Meeting Date:

200 Laurel Lake
Drive

Request:

Major Site Plan to
construct 7 duplex villa
buildings

Fig. 1 - June 9, 2025 PC Submittal

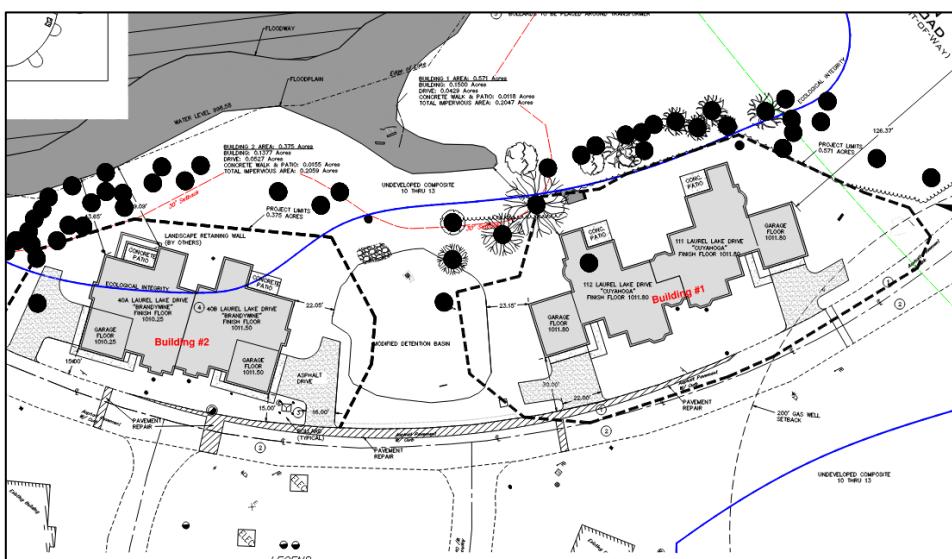
- Buildings #1 and #2 have been repositioned. Building #2 has been redesigned to a duplex with side loaded garages and is located further from the access drive. The proposed stormwater pond has been reconfigured.

Fig. 3 June 9, 2025 PC Submittal

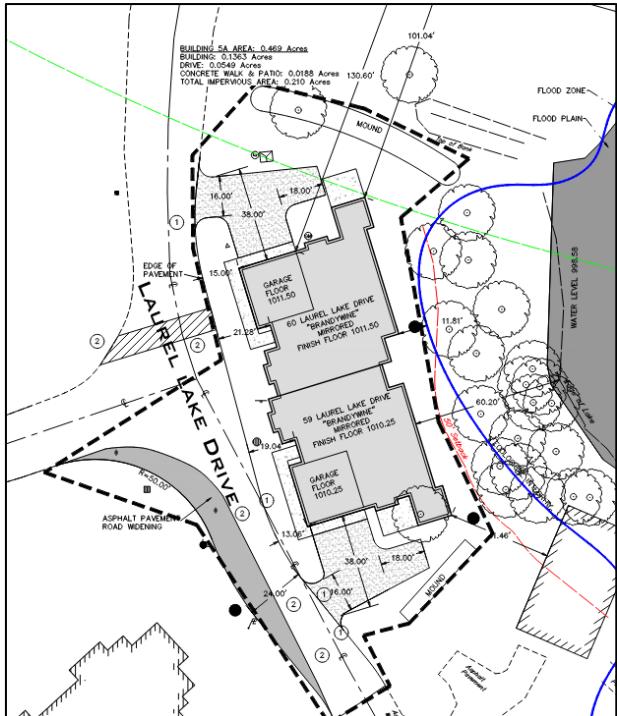
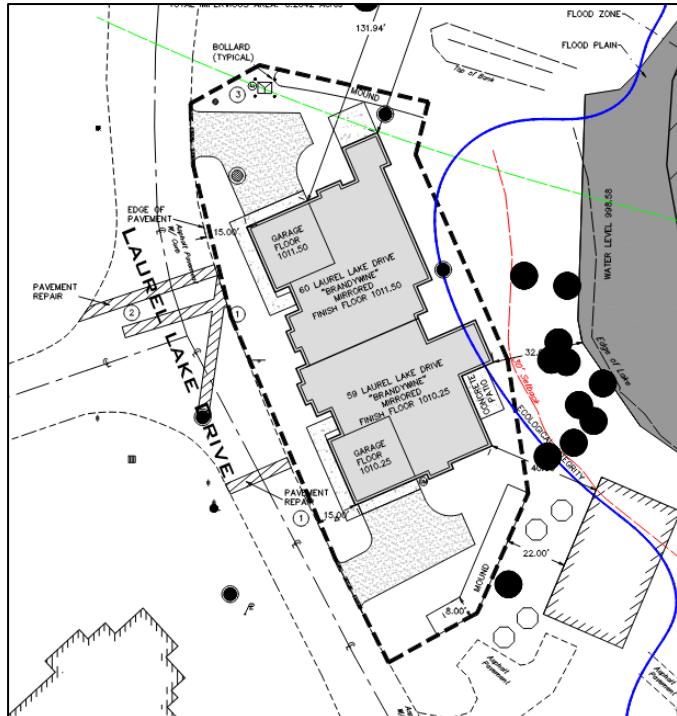
2. The applicant is no longer requesting to realign the access drive. The building has been slightly redesigned allowing the existing drive to remain in place.

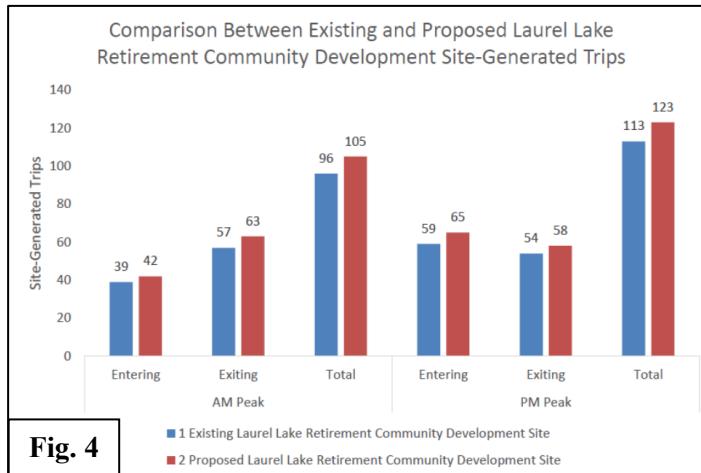
- The number of anticipated vehicle trips would be low per the following chart (See Figure 4).
- The proposed driveways and resulting sight distances would meet the most recent edition of the *Federal Manual of Traffic Control Devices 11th Edition, December 2023*.

Fig. 5

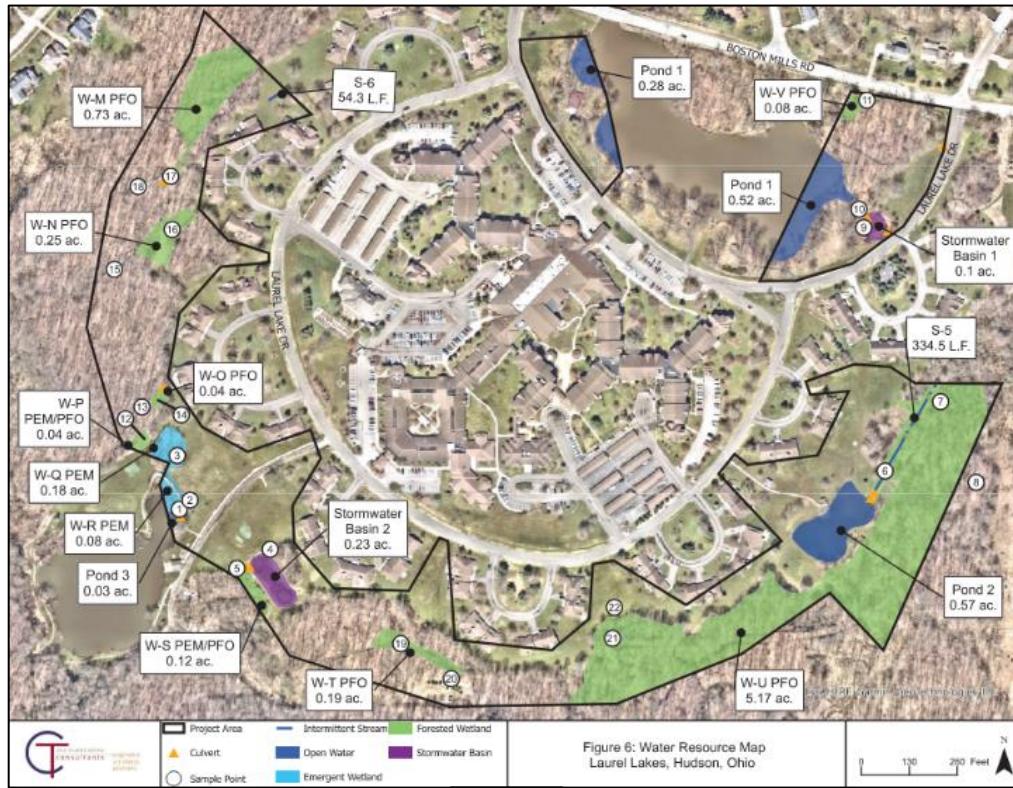
Updates to Application: The applicant has submitted a letter with the current Planning Commission submittal. The letter was written by Carrie Ricker, Project manager and profession wetland specialist, of Verdantas (formerly CT Consultants), the environmental science and engineering firm that has completed the environmental documentation for the site . The letter states: *Verdantas, LLC (formerly CT Consultants, Inc.) prepared the Wetland Delineation Report for the Laurel Lake, Hudson, Ohio property in August 2022. We have been requested to provide clarification around Pond-1 jurisdiction and the type of surface water feature this is considered. Pond-1 as labeled on the attached Water Resource Map for Laurel Lake (see Figure 5), is considered a tributary impoundment under (a)(3) of the Waters of the United States (WOTUS) Regulatory Ruling. Pond-1 does not contain wetland vegetation and is not considered a wetland by definition. This feature is an open water impoundment that extends upstream as a part of Lake Forest on the north side of Boston Mills Road. This feature is an impoundment of an unnamed tributary to*

Fig. 8

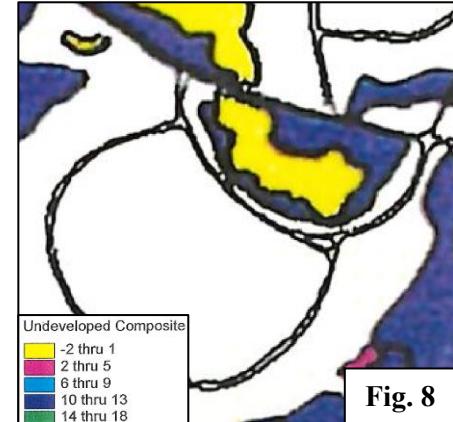
Update to Application: Staff notes minimal change to the site plan relative to this requirement; however, the applicant’s determination on the classification of the pond vs. wetland would relate to this analysis. Staff notes; while the pond shore area itself is classified under the lowest Index of Ecological Integrity Composite, the surround area falls under the two highest (see Figure 8). The applicant has labeled this area on the submitted site plans.

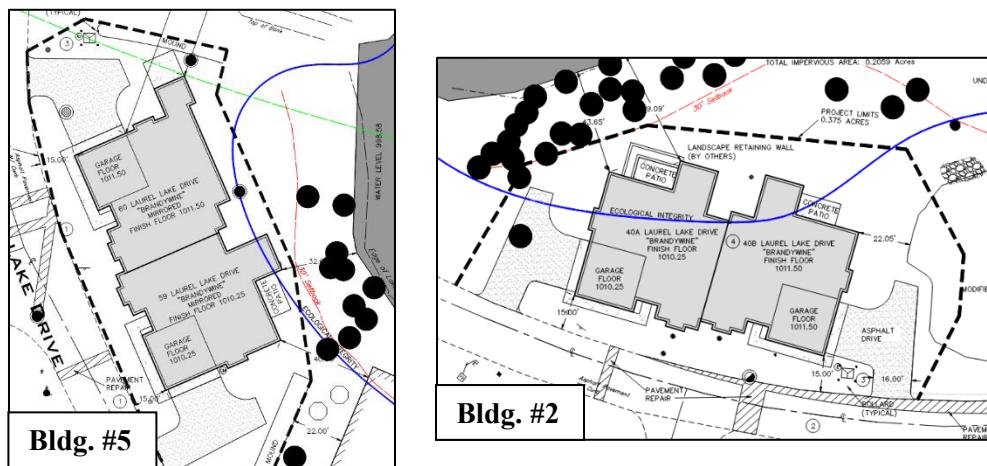
Staff Comment: Staff notes minor changes to the proposed clearing plan have been proposed with the redesign. Buildings #2 and #5 would encroach into the ecological integrity priority retention area; however, neither building proposed encroachment with the previous submittal. Staff recommends the following:

Building #2: The revisions to Building #2 as a duplex would further encroach into the Index of Ecological Integrity priority retention area than the previous plan. Staff recommends Building #2 be revised back to a single unit with the limits of disturbance established outside of the ecological index retention area.

Building #5: Revise the design so the building footprint is located outside of the ecological retention area.
